# City of El Paso - City Plan Commission Staff Report

Case No: SUSC13-00001 Montecillo Unit Five

**Application Type:** Major Preliminary **CPC Hearing Date:** April 4, 2013

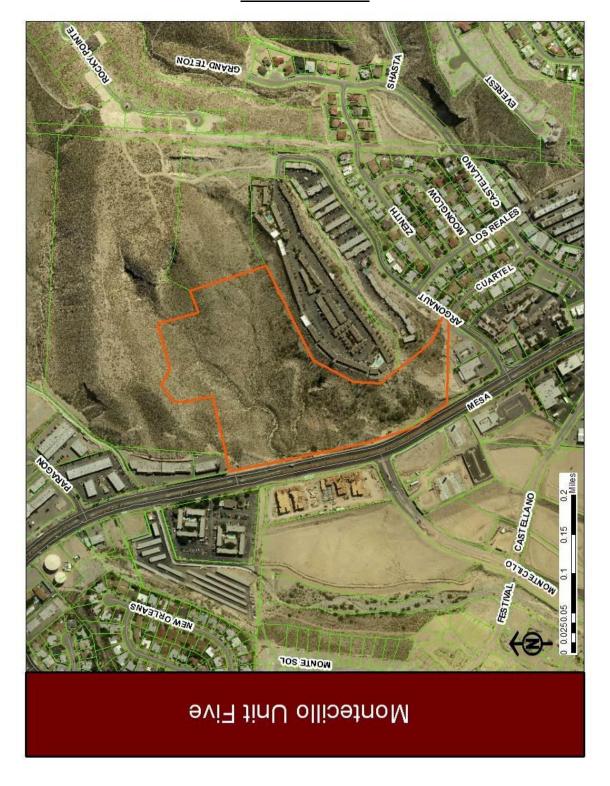
- 1. Clarify the purpose / intent of creating two lots (Lot 1, Block 11 & Lot 2, Block 11) with-in the same area noted as "Park / Open Space" and with the same Transect Zone (T-1) designation.

- 2. Clarify if the Commercial Streets (CS 55-29), The Frontage Roads (CS 51-32 & CS 48-24) and the Frontage Road w / Bus Stop (CS 45-35) as shown on the Montecillo Development Regulating Plan Thoroughfare Assignment Plan need to be reflected on this plat.

- 3. Per site visit observations (see photos), concrete flumes, drainage structures and surface flow storm water run-off is coming from the King Hills Apartments (southeast property) and running thru the "Park / Open Space" area; clarify if drainage easements are to be proposed / required.

- 4. Parks Department recommends for the area labeled as "Park / Open Space" area (Lot 2, Block 11) be labeled as Stormwater Open Space.
- 5. Clarify ownership / purpose of the 10' R.O.W. & Easement (Vol. 366, Pg. 883) located within the "Park / Open Space" area south of the King Hills Apartments, and clarify if to remain or be vacated by this plat.
